STOCKTON UNIFIED SCHOOL DISTRICT

Expanded Learning Opportunities Program (ELOP) - Relocatable Classroom Buildings

The following additions, deletions and revisions to the plans, specifications and Addenda shall become a part of the plans and specifications. It is the responsibility of the General Contractor to submit the information contained in this addendum to all subcontractors and suppliers. The Bidder shall acknowledge receipt of the Addendum in the Bid Proposal. (Addendum number of pages: **32** pages + **77** attachments = **109** total pages).

AD1-TAY-
 A202

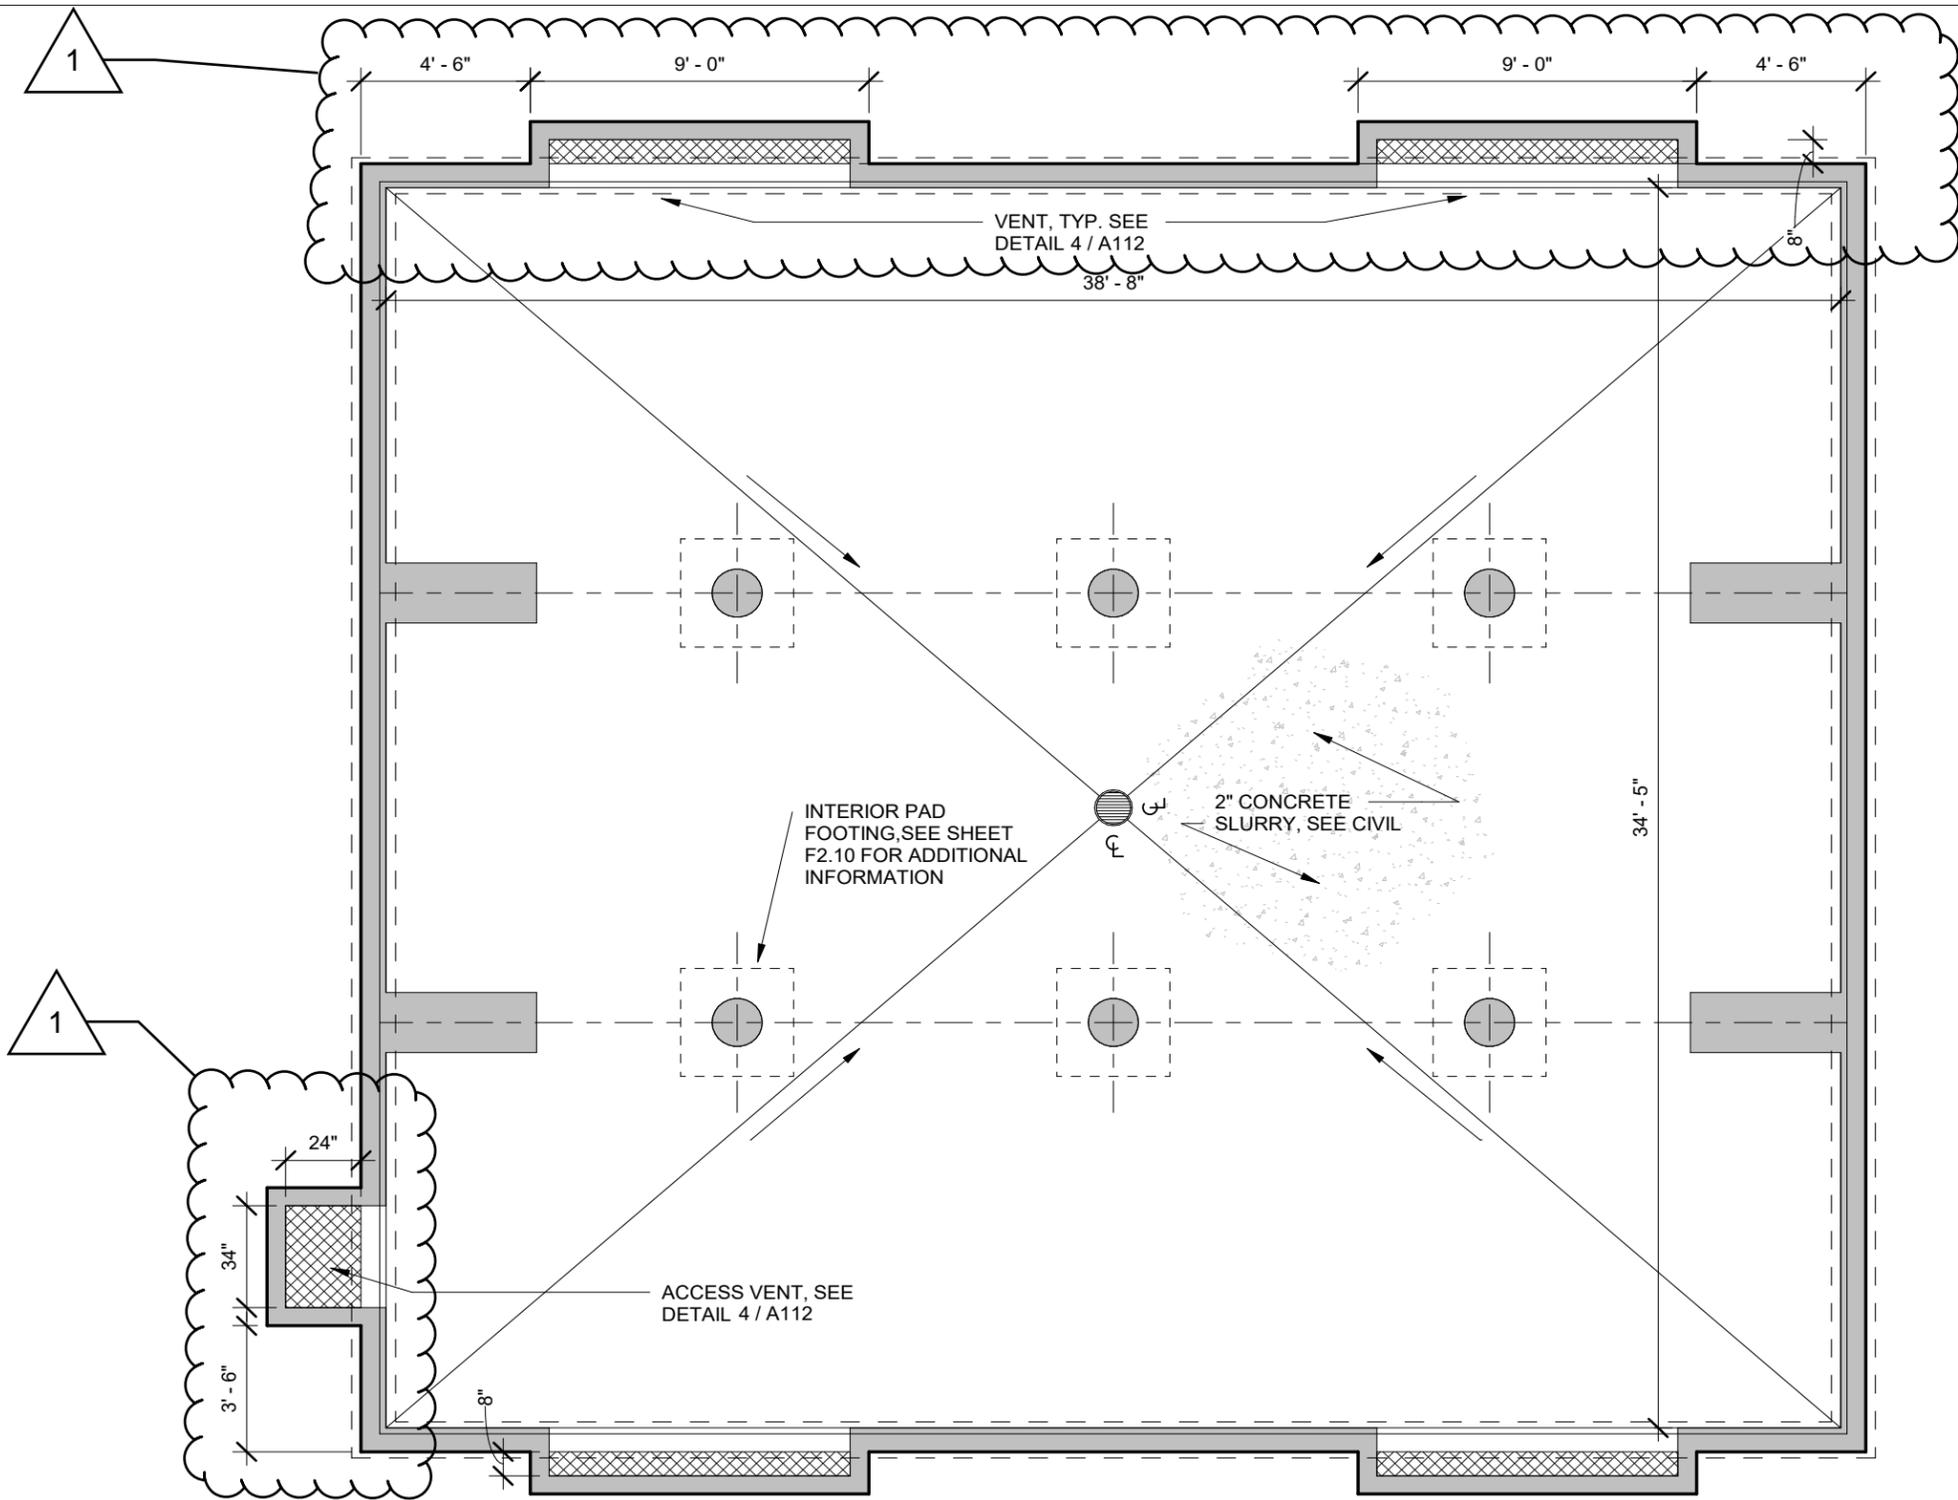
1 - 023: DRAWINGS SHEET A202 - “VENTING FLOOR PLANS”, revise as follows:A. Per attached drawing **AD1-TAY-A202.**

1. Reflected ceiling plan – Perforated panel venting has been added.
2. Dimensions removed

AD1-PUL-
A801

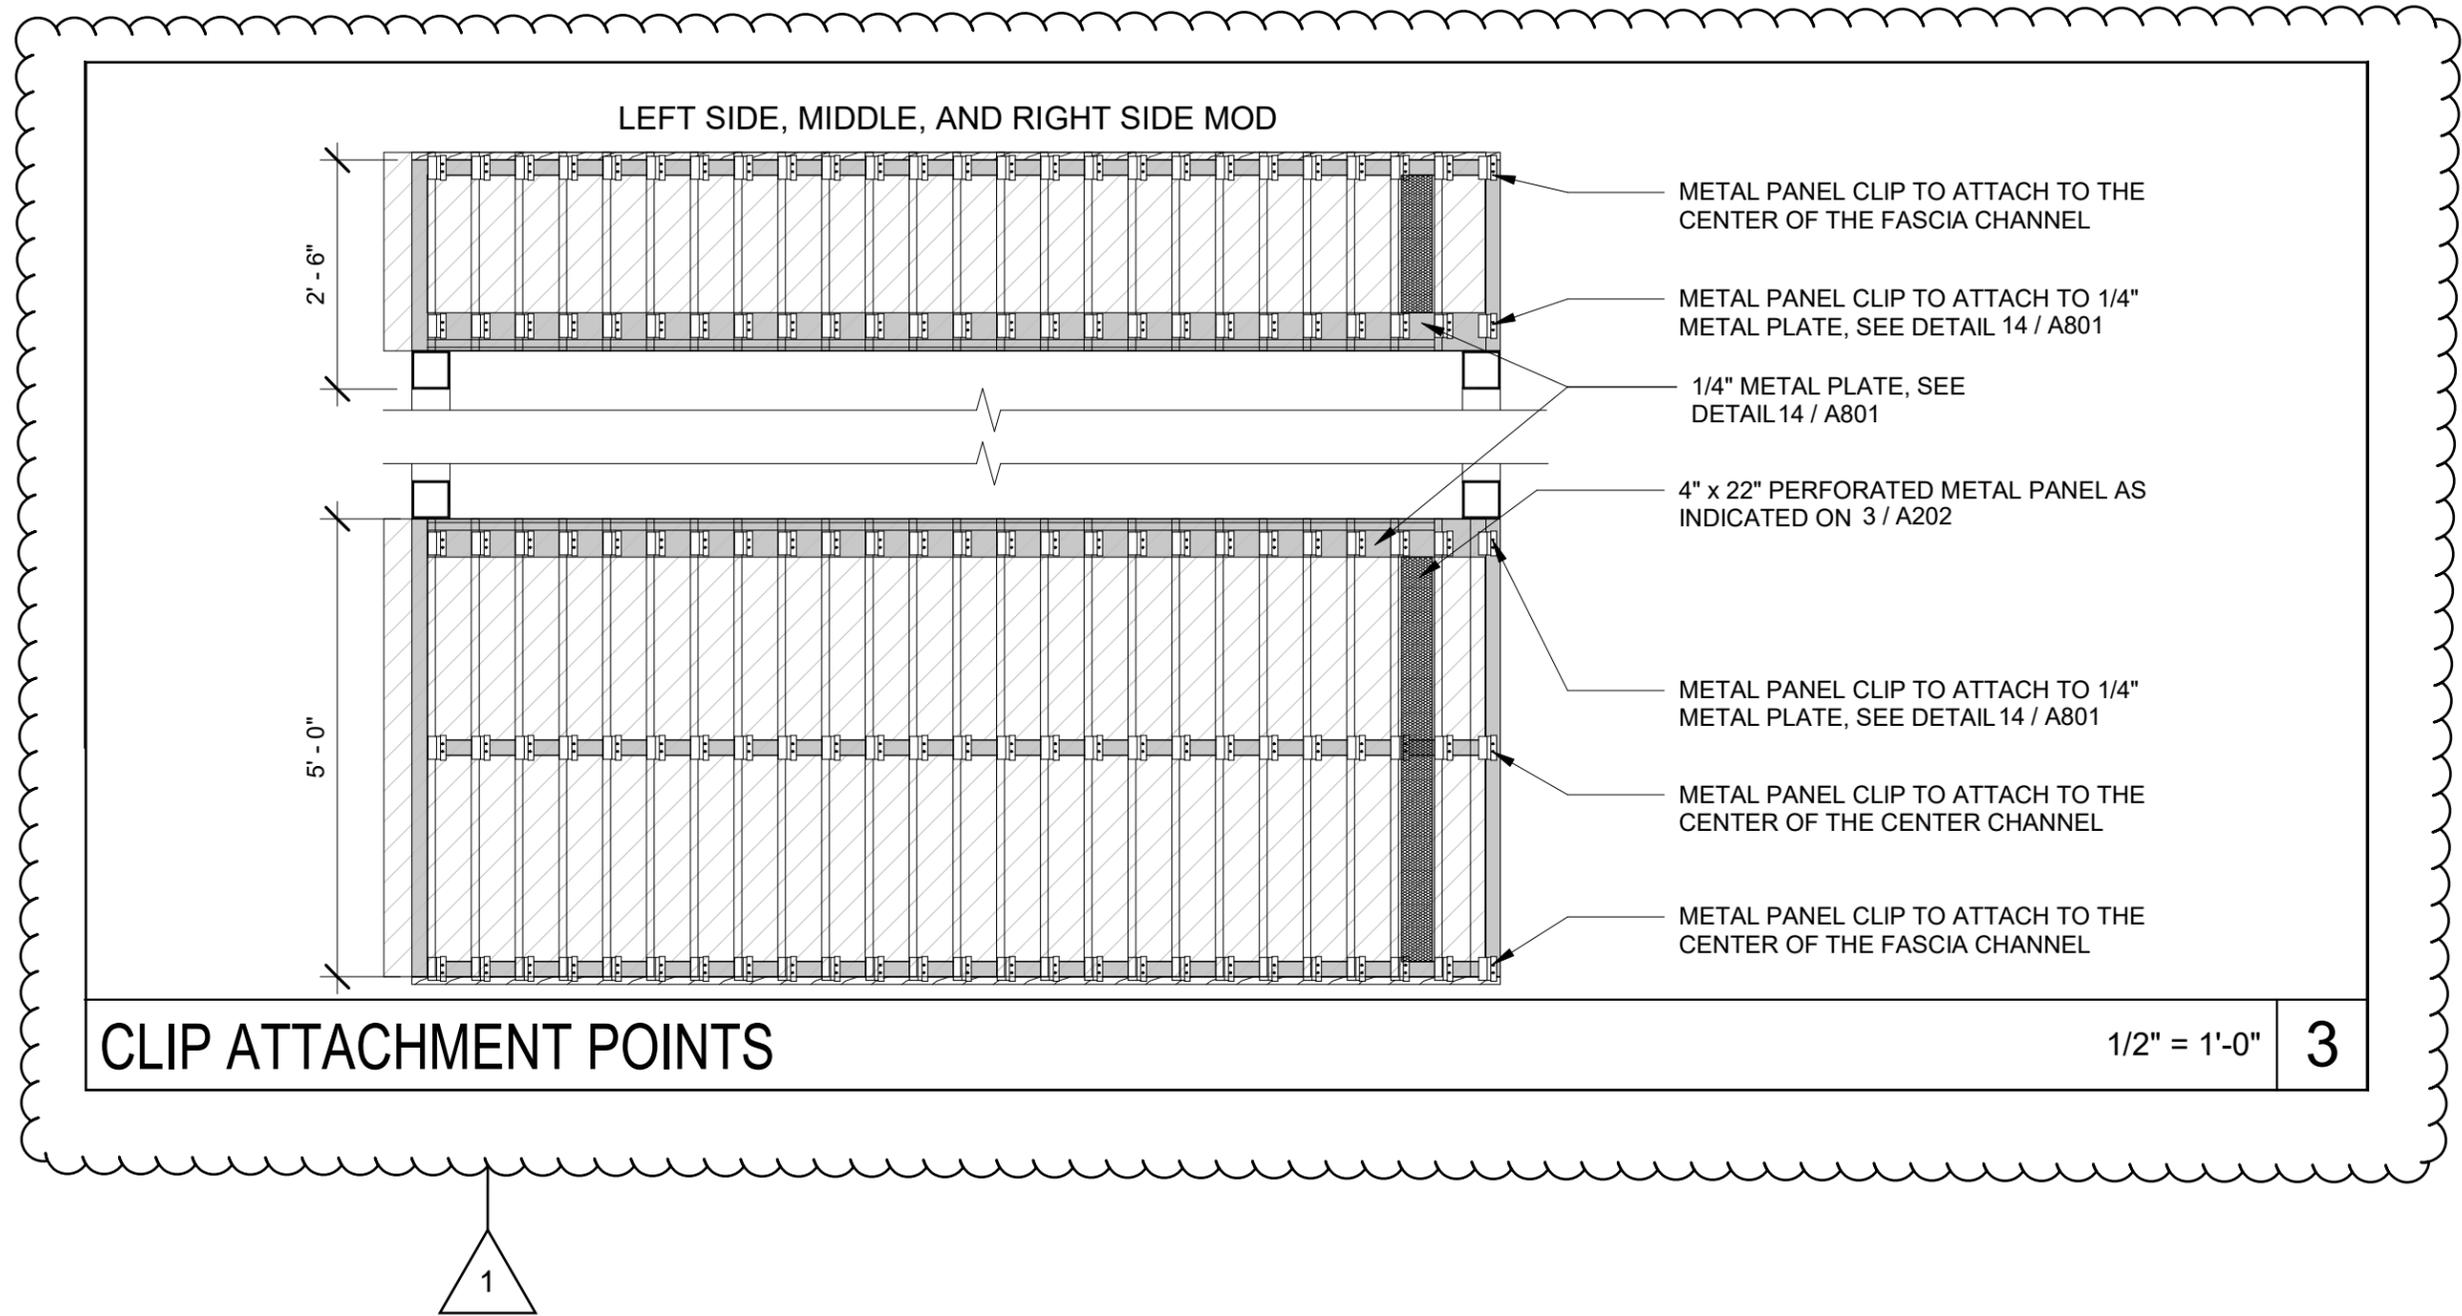
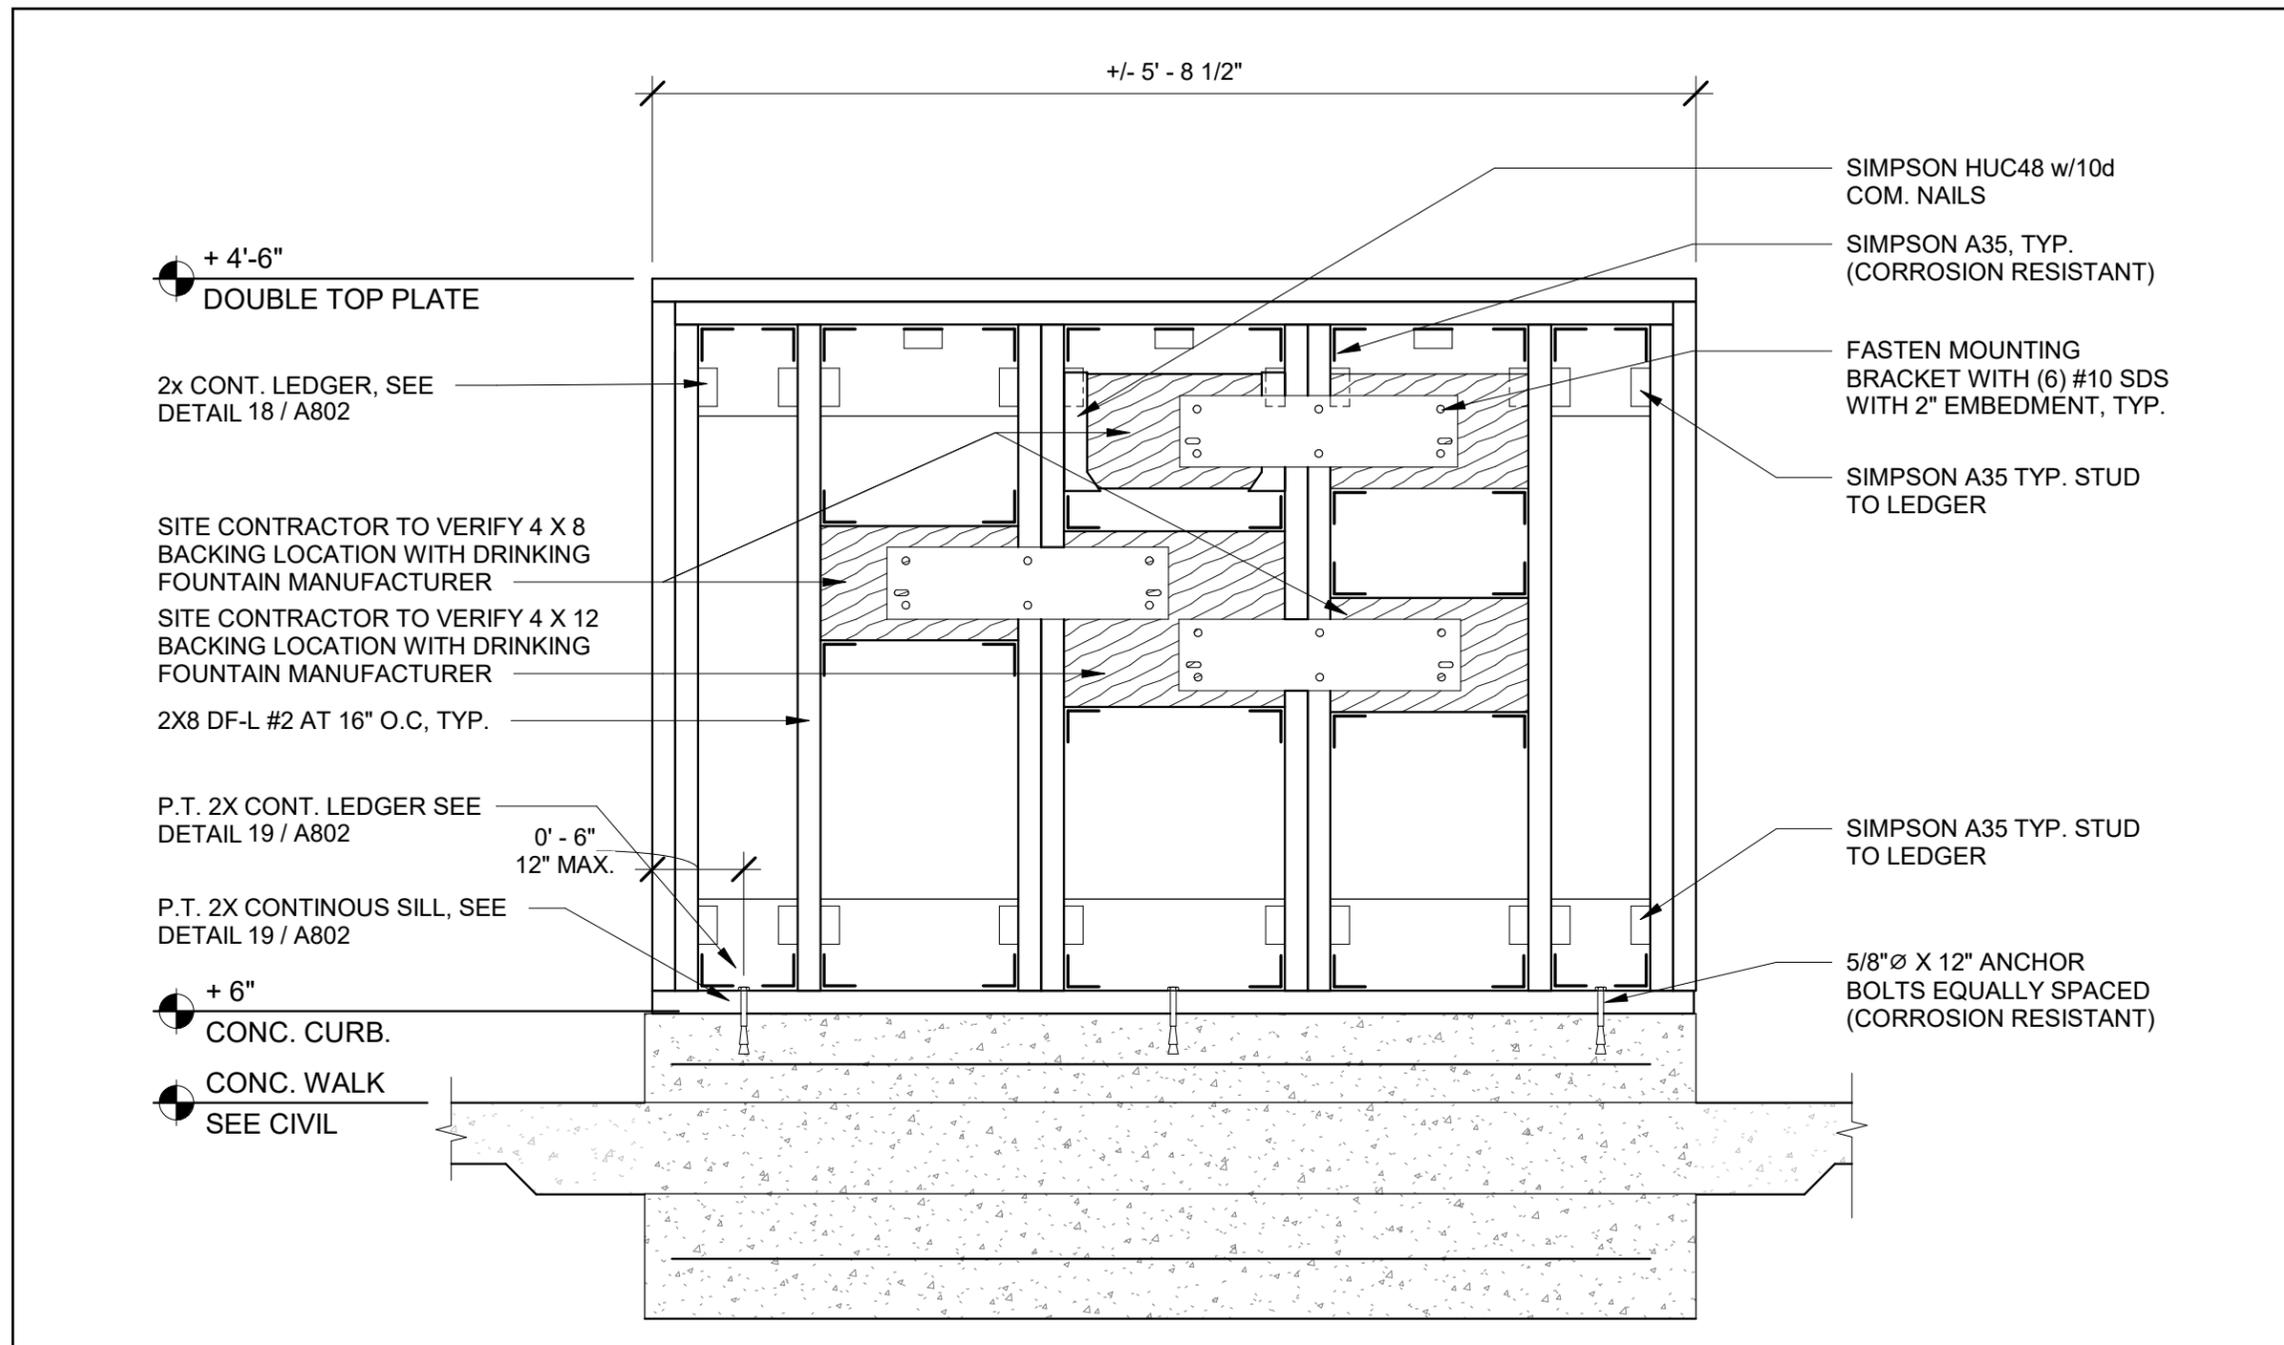
- 2. Reflected ceiling plan – Perforated panel venting has been added.
- 1 - 036: DRAWINGS, SHEET A801 - “EXTERIOR DETAILS”**, revise as follows:
- A. Detail 14 – Clip fastener note revise to “(2) #12 SMS w/3 THRED INTO STRUCTURE PER CLIP”

- B. Per attached drawing **AD1-PUL-A801**
 - 1. Detail 15 and 16 - Additional fastener information has been provided.
- 1 - 037: DRAWINGS, SHEET A802 – “EXTERIOR DETAILS”**, revise as follows:

ELECTRICAL SITE PLAN

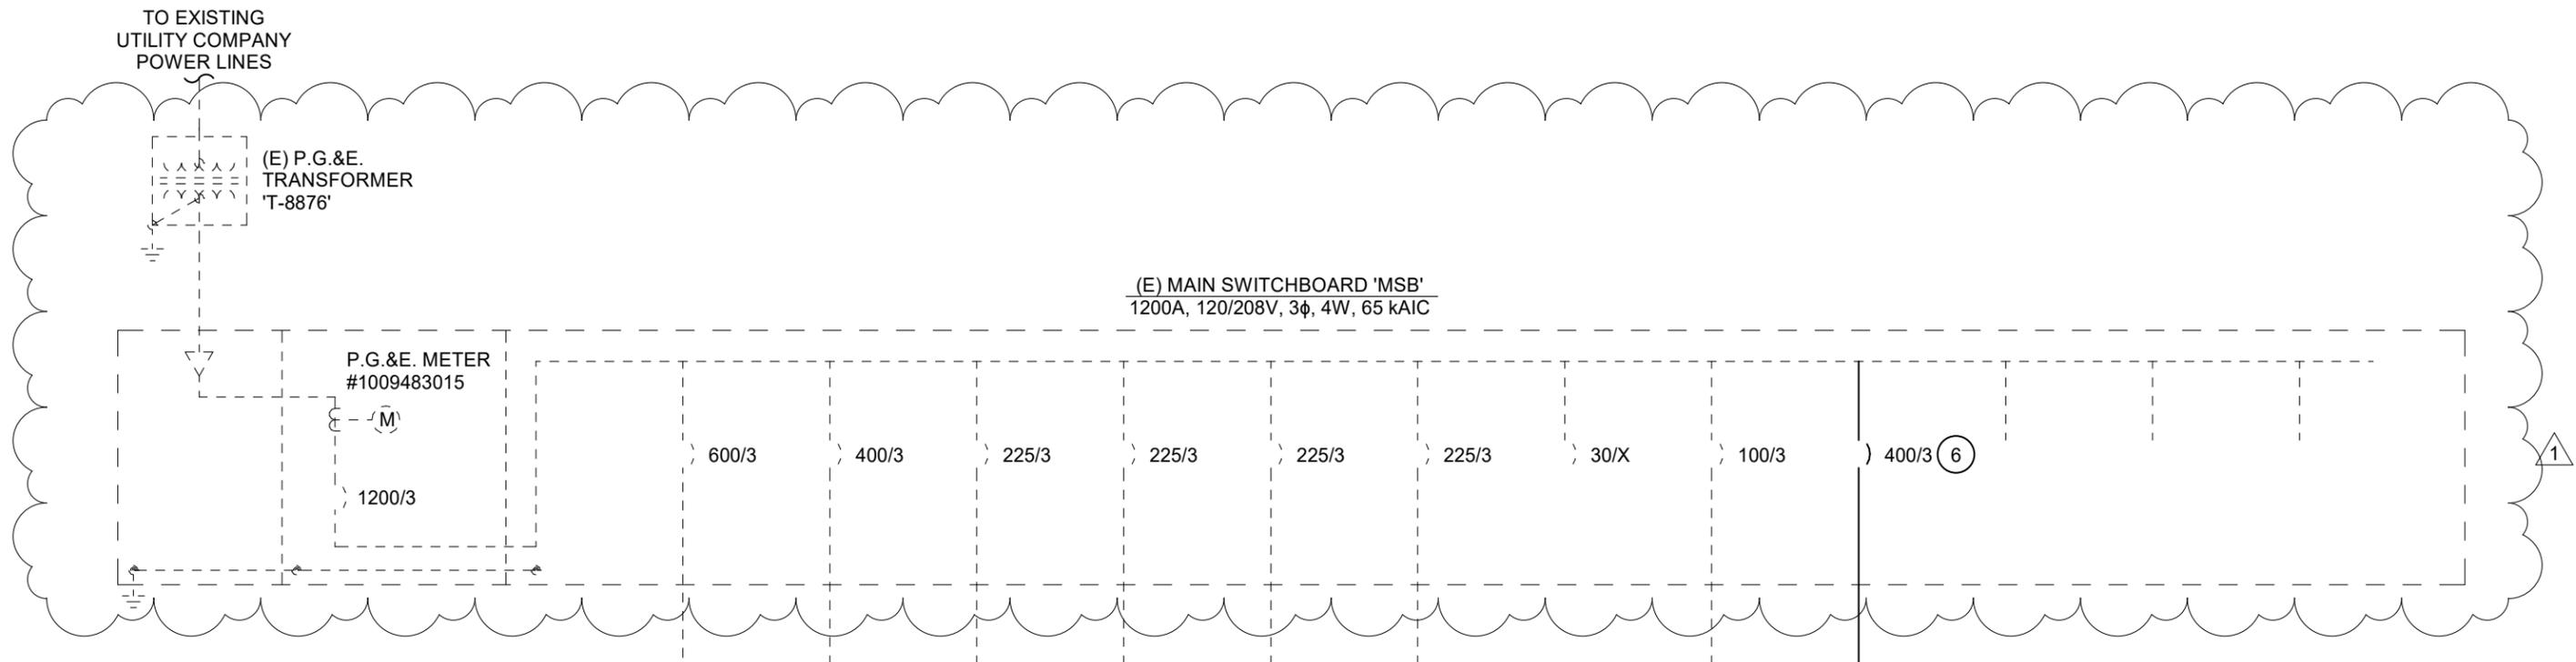
1 - 038: DRAWINGS, SHEET E100 – “ELECTRICAL SITE PLAN”, revise as follows:

A. Per attached drawing **AD1-PUL-E100**

1. Sheet revised, existing switchgear to remain.
